Agenda – City Centre Community Committee – April 9, 2019

**Item No. 4 Subdivision and Rezoning – 206, 216, 218, 228, 230, 236, 244 and 248
Good Street
(Fort Rouge – East Fort Garry Ward)
File DASZ 28/2018 [c/r DAV 184543/2018D]**

Title: DASZ 28/2018 – 206-248 Good St

Issue: For consideration at the public hearing for a subdivision and rezoning for the construction of a 6-storey, 145-unit residential building.

Appendix 1 - Main floor height visualization

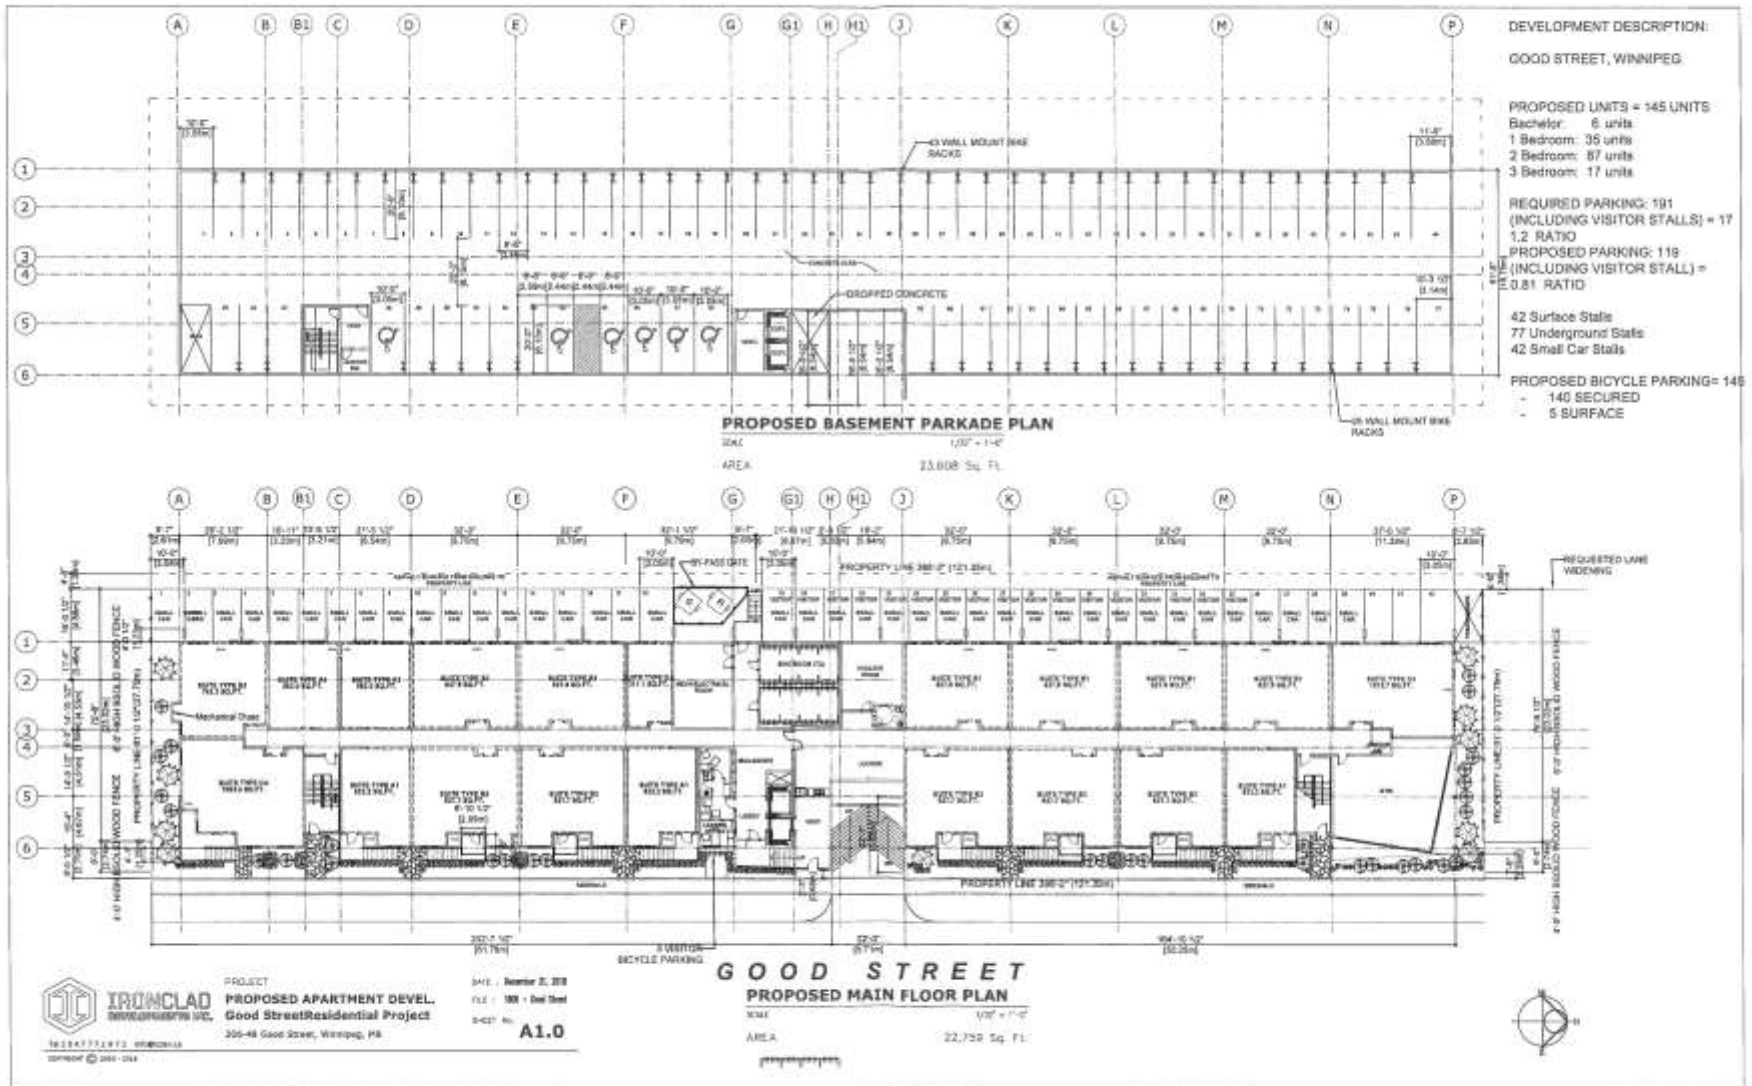
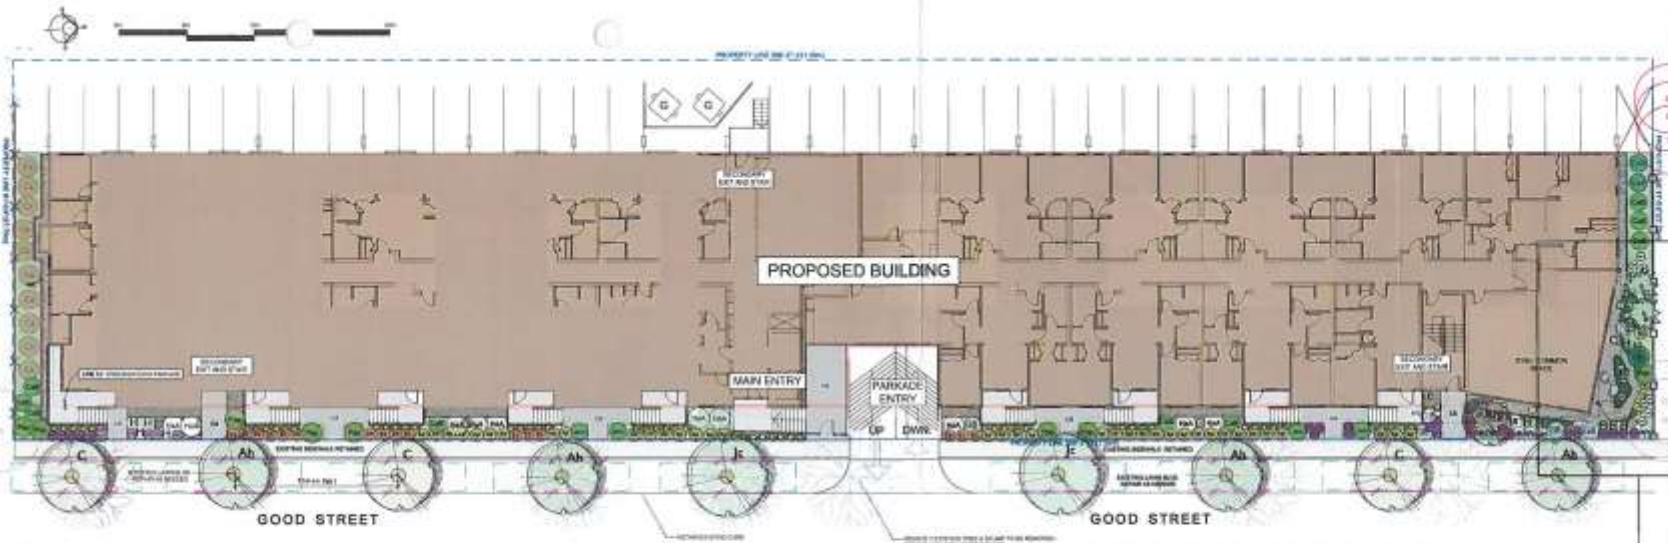
- For the proposed development, the plans show that the building face on Good St. contains a series of 10-step staircases leading up to a raised main floor along the 390 ft. length. Below that, at street level, there is a brick wall concealing a parking garage.

- With an average step height being 7.5-7.75 inches, a 10-step staircase equates to approximately 6-6.5 ft. of height. This means that the ground floor of the building will be above the heads of most people, and the presentation against the sidewalk for the majority of the 390 ft. length of the building will be brick wall. See Figure 2 below for a depiction of this condition.

Figure 3: Main floor height visualization. See Appendix 1 for larger view.

- The plans show that the main floor of the building is raised 6-6.5 ft. above ground level. This removes the 'life' of the building away from street level. It leaves a brick wall and a series of 10-step staircases for the first 6-6.5 ft. above street level. The pedestrian experience is negatively impacted because a brick wall provides no interplay between interior and exterior of the building at the sidewalk level, which can have a 'deadening' effect on the street condition.

- 1) Lower the building so that the main floor is either at grade or projects no more than approximately ~3 ft. above grade.
- 2) If greater ramp length is needed to reach a lower parkade floor, curve/ turn the parkade ramp, or provide ramp access in the side yard.
- 3) If parking stalls are not feasible to provide off the lane, remove those stalls and submit a parking management plan that includes the provision of car share vehicles in order to help offset the resulting parking shortage.
